Addendum No. 1

PROJECT: Lewis & Clark Regional Water System
Banner Job No. 20000.42.01
HDR Project No. 10084546

CONTRACT: Replace Angle Wells at Sites C and D Project

ADDENDUM ISSUE DATE: May 30, 2018

FILENAME	01D-101.DWG	SHEET
	SCALE	AS NOTED	01D-101

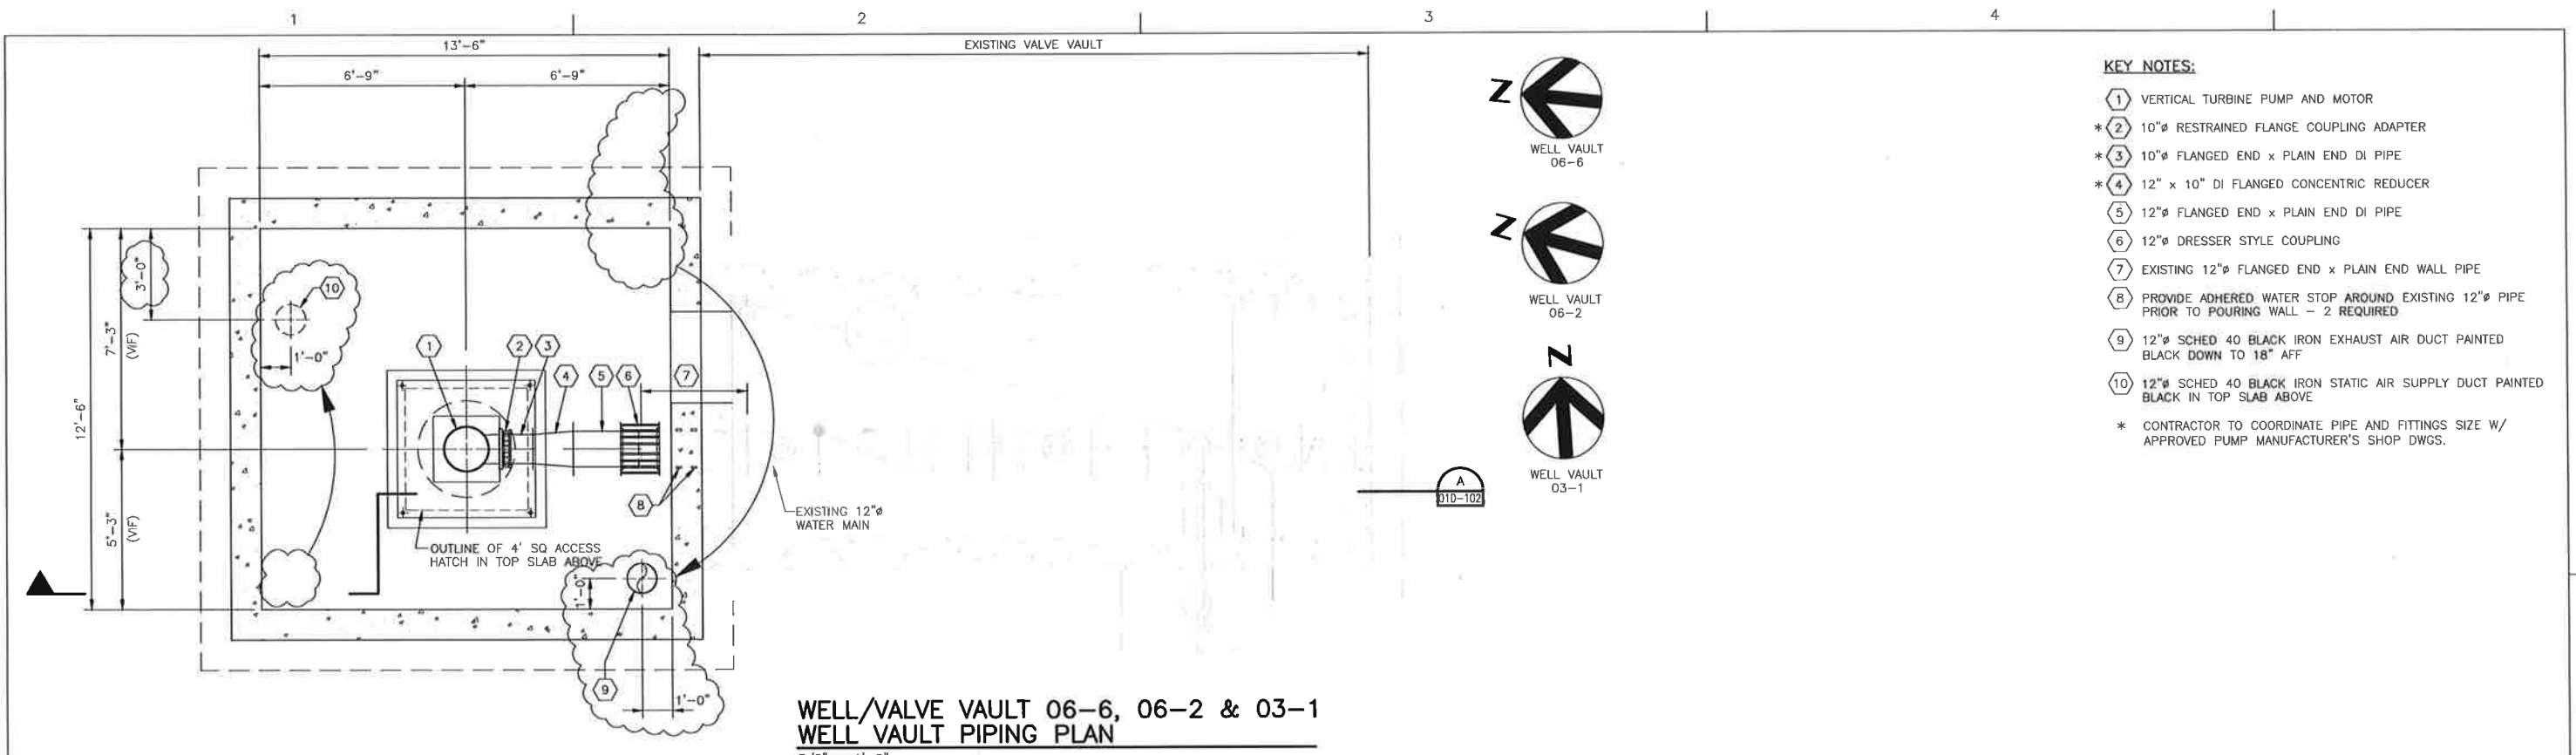
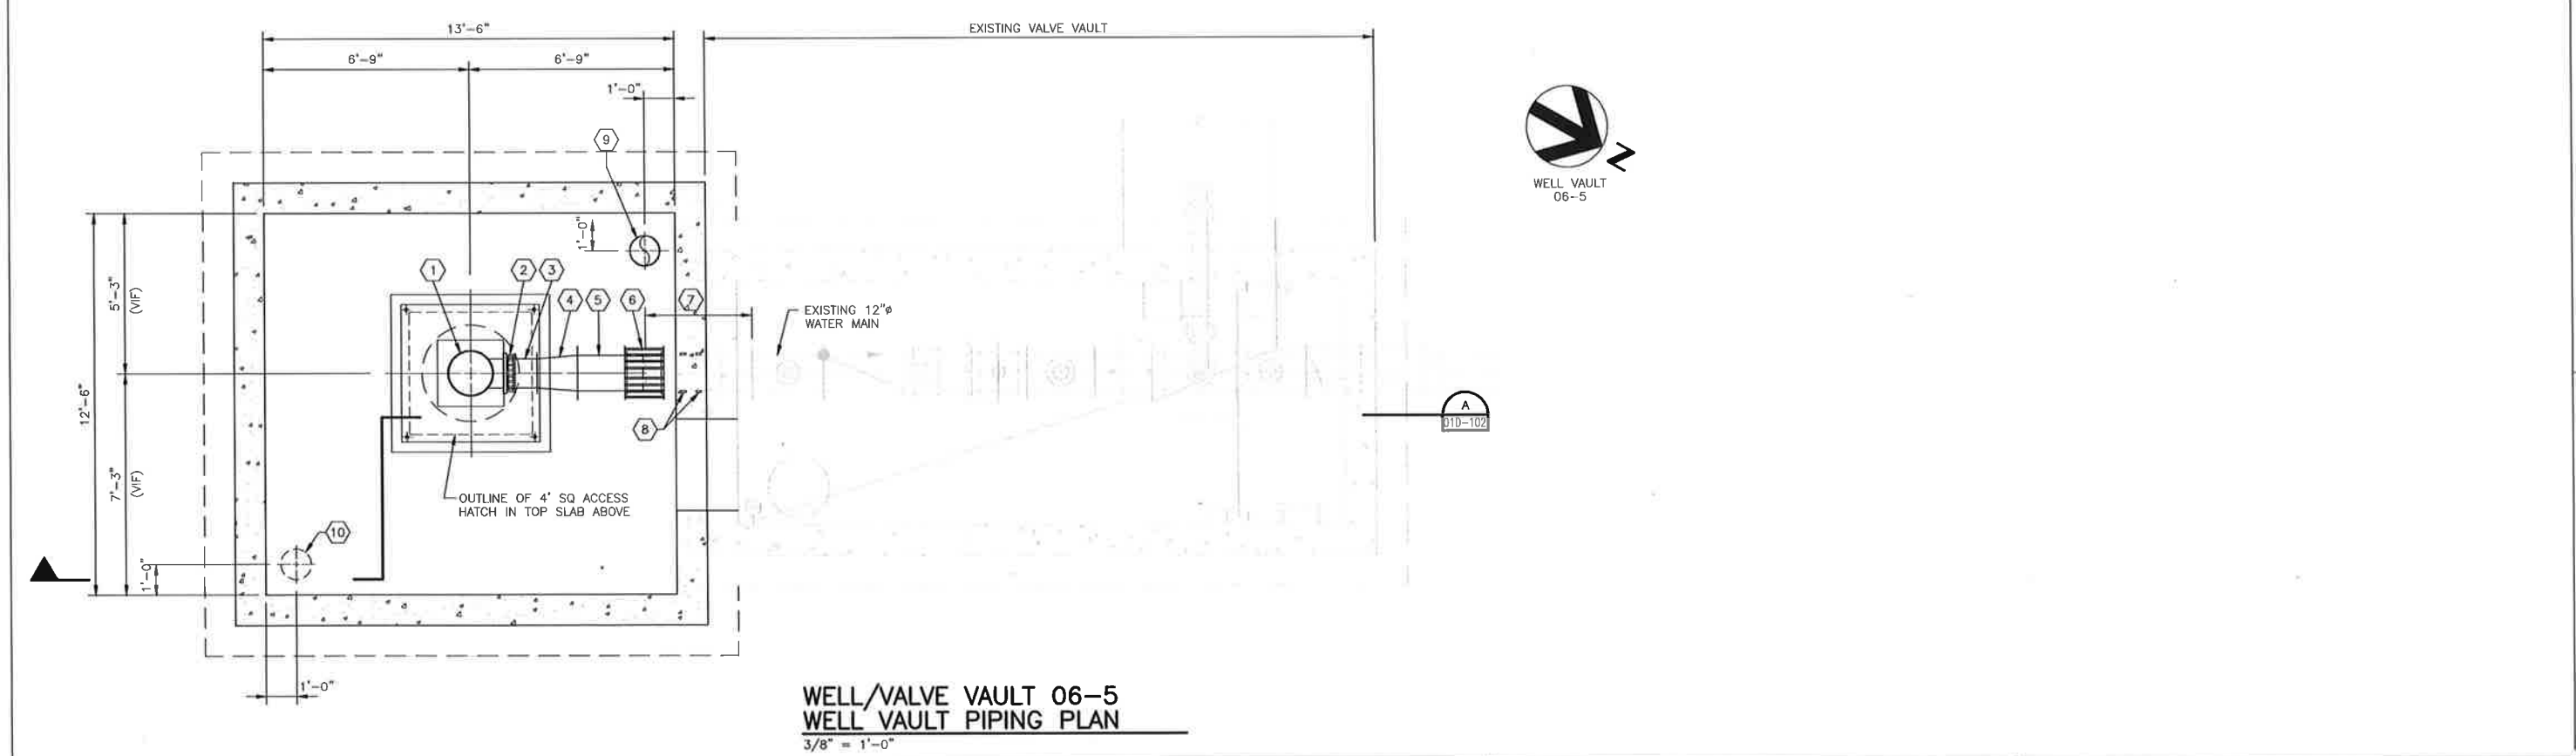
3. PLAN SHEET 01D-101

- a. *Change:* “BLACK” to “TAN TO MATCH EXISTING” on Key notes 9 & 10.
- b. *Move:* Exhaust fan & duct location along with key note 9 on the plan for Vaults 06-6, 06-2 and 03-1 from the upper right corner of the new vault of the plan to the lower right. Conversely move the supply air duct and key note 10 from the lower left to the upper left corner of the new vault. This locates the exhaust fan and duct to be on the backside of the pump discharge piping from the perspective of the access door, similar to the plan for Vault 06-5 on this sheet.
- c. *Remove:* Section cut “A” from the plan for Vaults 06-6, 06-2 and 03-1. See attached revised Sheet 01D-101

FILENAME: 01E-103.DWG
SCALE: AS NOTED
SHEET: 01E-103

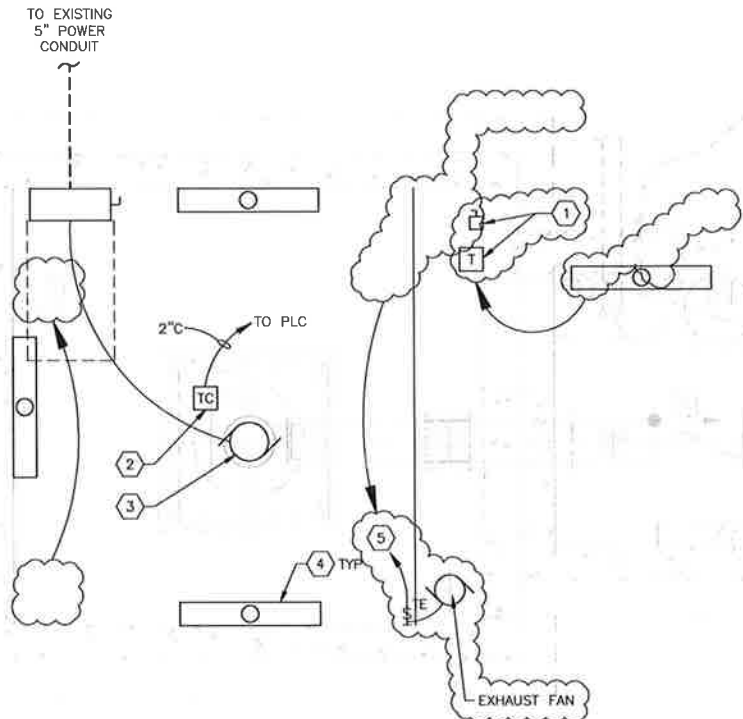
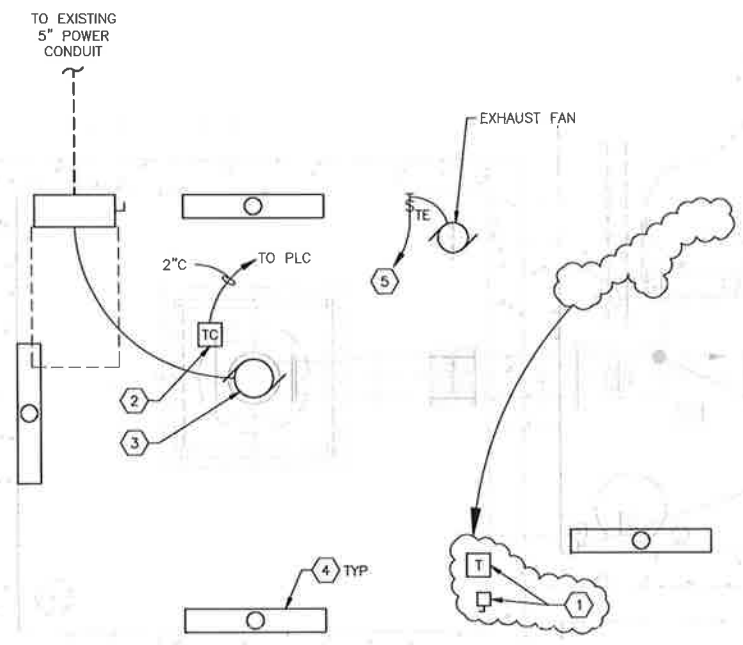
4. PLAN SHEET 01E-103

- a. *Move:* Exhaust fan & duct location on the plan for Vaults 06-6, 06-2 and 03-1 from the upper right corner of the new vault of the plan to the lower right. Conversely move the supply air duct from the lower left to the upper left corner of the new vault. This locates the exhaust fan and duct to be on the backside of the pump discharge piping from the perspective of the access door, similar to the plan for Vault 06-5 on this sheet. See attached revised Sheet 01E-103.
- b. *Change:* Move the location of relocated safety and disconnect switches described in Keyed Note 1 from the wall in the existing vault as shown to be

adjacent to the door in the new vaults, right side as you enter new vault for
Vaults 06-6, 06-2 and 03-1 and to the left on Vault 06-5. See attached revised
Sheet 01E-103.
